DEPARTMENTAL COMMUNICATION

Re: GPW-16892 Catch assy Hood

CATCH ASSY - HOOD
SAMPLE TO BE APPROVED BY ENG. DEPT.
FINISH - SEE PAINT SPEC.

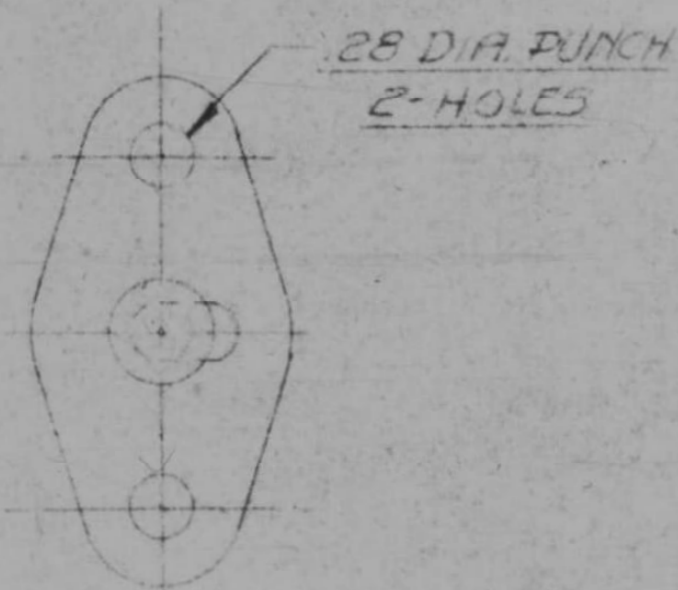
Please add the note (Pack Spring with M-4601-A Grease or Equal. at assy.) omitted on the above drawing when released.

Make this change as soon as possible as suppliers are sending these in to us without the Grease and we have to improvise means of lubricating after assy. and this is expensive.
